**Norfolk Boreas Offshore Wind Farm**

# **Statement of Common Ground**

**Highways England**

Applicant: Norfolk Boreas Limited  
Document Reference: ExA.SoCG-8.D9.V2  
Deadline 9

DRAWN	J1	CHECKED	RNE	APPROVED	ADR
DATE	11.02.19	SCALE AT A1	1:500 up to	CLIENTS REF.	
DRAWING No.	TP-PB4476-DR025				REVISION
CLIENT DWG No.					D0.1

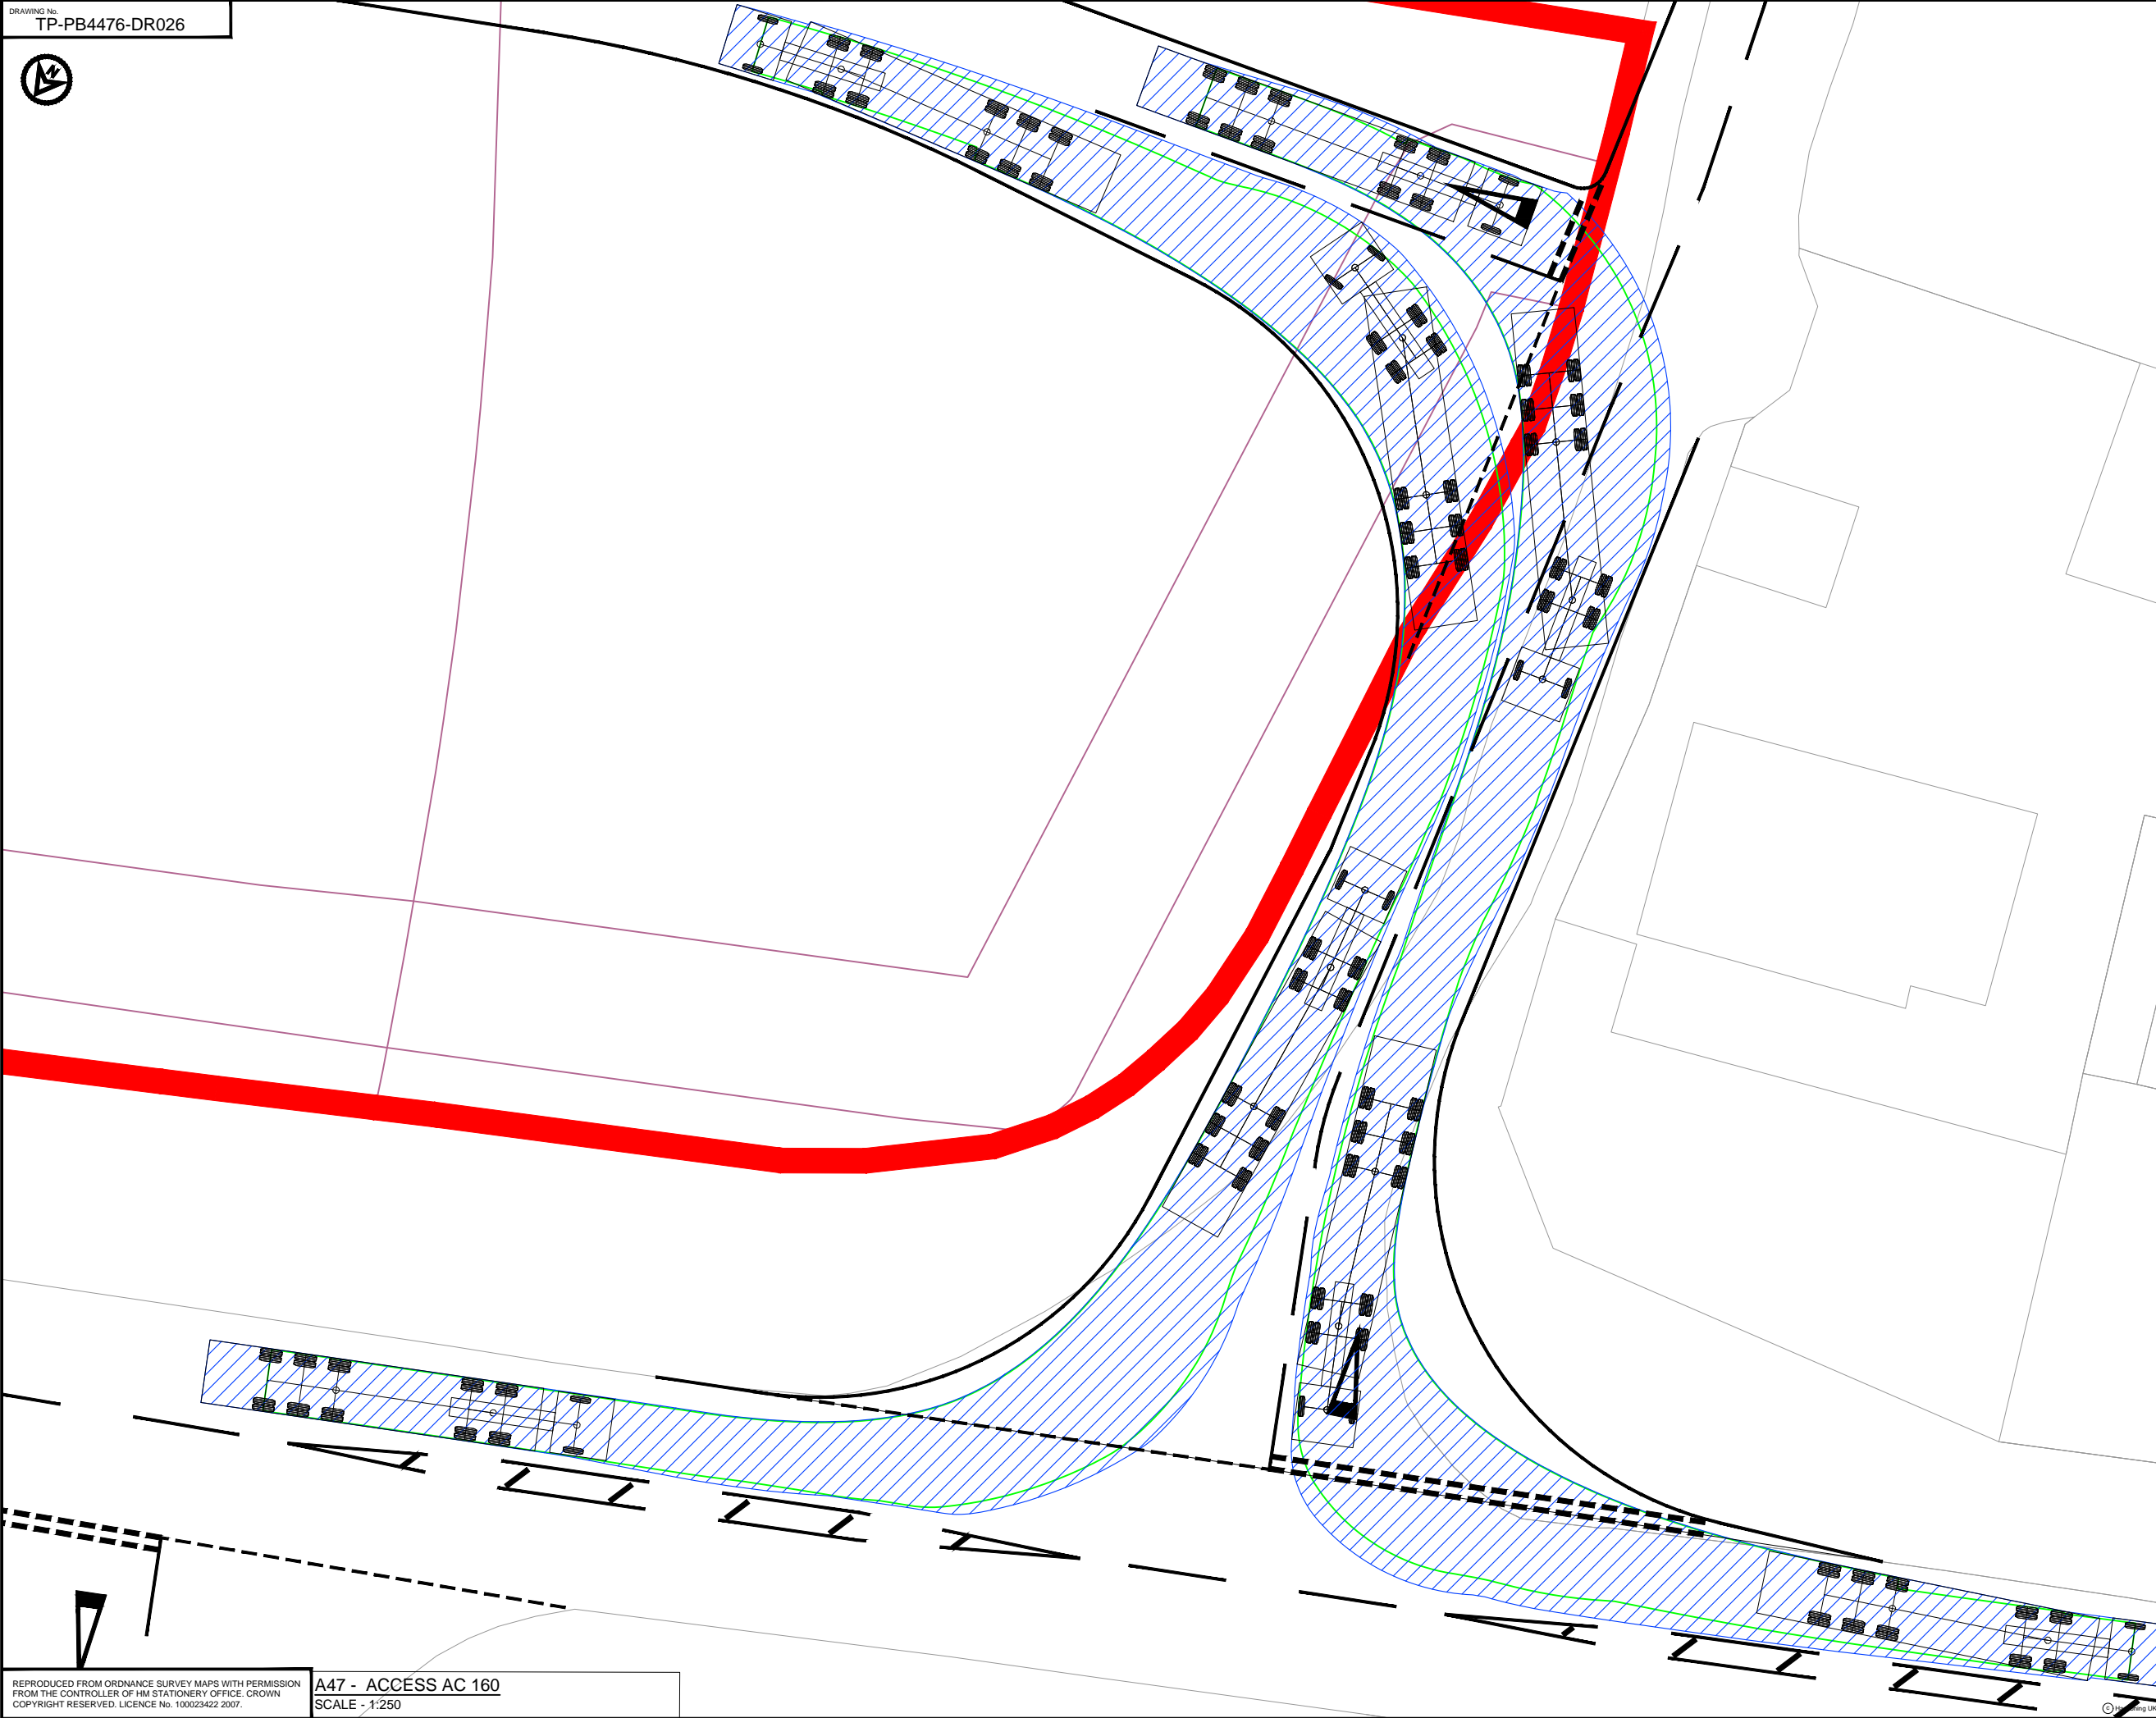
15. The layout of site access junction AC160 illustrated on Drawing PB4476-DR025 D0.1 appears to provide satisfactory geometry to accommodate heavy vehicles turning to and from the A47. There is no suggestion that the use of this junction by vehicles accessing the works would give rise to a queue of stationary traffic within Bushy Common Road waiting to enter the site, such as would risk generating a queue of traffic back to the A47, some 50m away.

19. The layout of the improved junction between the A47 and Bushy Common Road, illustrated on Drawing PB4476-DR025 D0.1, appears to provide in full for the requirements of DMRB Design Standard TD42 for this type of junction. In addition, the swept path plots shown on Drawings PB4476-DR026 and 027 show that it can accommodate heavy vehicles turning on and off the A47 without clipping kerb lines, and without encroaching on the wrong side of the A47 or the minor road.
